UNITED STATES PATENT AND TRADEMARK OFFICE

APPLICATION NO.	FILING DATE	FIRST NAMED INVENTOR	ATTORNEY DOCKET NO.	CONFIRMATION NO.
09/648,588	08/25/2000	Michel Lesimple	10767-002001	6960

Office Action Summary	Application No. 09/648,588	Applicant(s) LESIMPLE, MICHEL	
	Examiner Charles E. Cooley	Art Unit 1723

FIG. 2

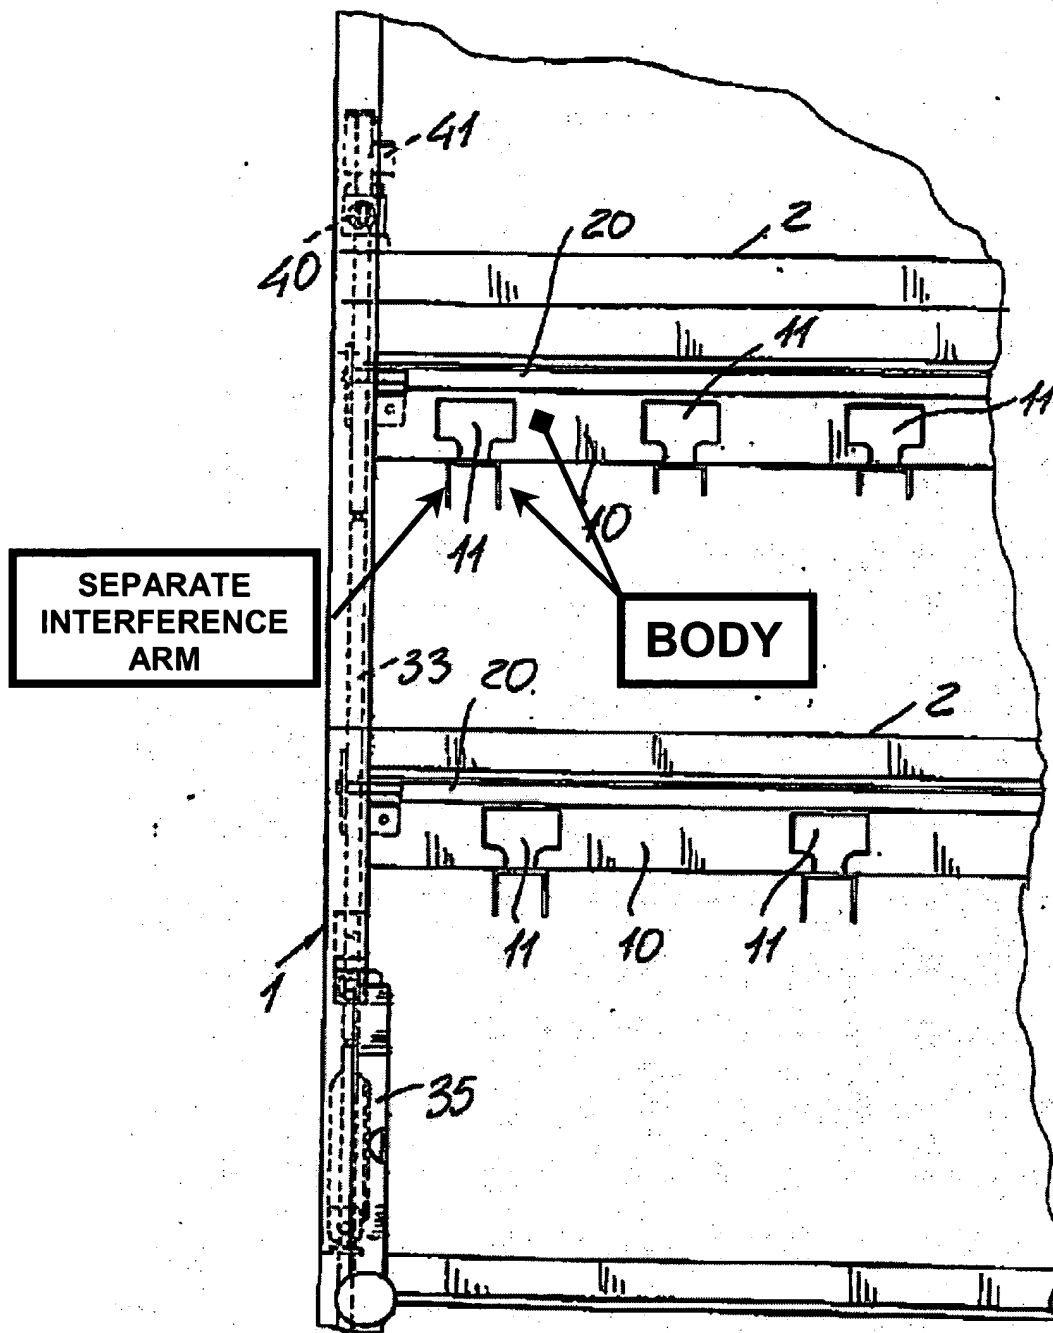
IT 1250630 discloses a system for stirring paint in an insertable can comprising a container/can 3 with a can cover and a stirrer within the can having a drive shaft (below 4); a can support shelf 2 below the can; an individual stirring head (which may be used with a single can or multiple cans which is nothing but an intended use not germane to patentability) positioned above the shelf that engages the stirrer to rotate the stirrer in the can when the can is inserted on the shelf, the stirring head comprising a body 10 (the element 10 and one of the downwardly depending flange members below 11 - as labeled in Figure 2 below) carrying a rotational stirrer drive mechanism (such as the pulley and depending drive shaft seen in Fig. 4); said body being shaped to trap the cover in position when the can is inserted on the shelf so that the drive shaft of the stirrer in the cover is drivingly aligned with the rotational drive mechanism in the stirring head (see Fig. 4); said body further including a separate interference arm (the left hand separate element seen below 11 in Fig. 3 and below 12 in Fig. 4 and as labeled in the Figure below) extending from above the location of the can downwardly toward the shelf that prevents rotation of the cover as the stirrer rotates within the can by mechanically interfering with the can cover as seen in Figs. 4-5; the stirrer in the can including a drive shaft which protrudes from the can cover as seen in Figs. 4-5; an engaging member 12 extending from the stirring head 10 which engages an upper portion of the drive shaft as seen in Figs. 4-5; a region between the stirring head and the shelf being free of obstructions as seen in Figs. 4-5; the head 10 is connected to a hollow shelf (another one of 2) arranged above the can cover as seen in Figs. 4-5; the shaft portion including a plate 4 with upwardly extending fingers and the engaging member 12 being a driver

with a blade actuatable with the fingers to effect rotation and the engaging member 12 engages the plate with fingers as seen in Figs. 4-5; the interference arm being a single arm assembly (e.g., the U-shaped arm seen in Fig. 3) or conversely being two downwardly extending arms (the two vertically disposed planar arms seen below 11 in Fig. 3); the can cover including a spout and the interference arm engages the spout as seen in Figs. 4-5; the shelf 2 being free of pins as clearly seen in the Figures.

With regard to the second matter, the element shown equivalent to the "separate interference arm" in Figure 2 above is a rotation preventing arm or flange that is a discrete and separate member (note "separate" is considered a very broad term) from the element 10 and the other laterally spaced and downwardly depending arm or flange
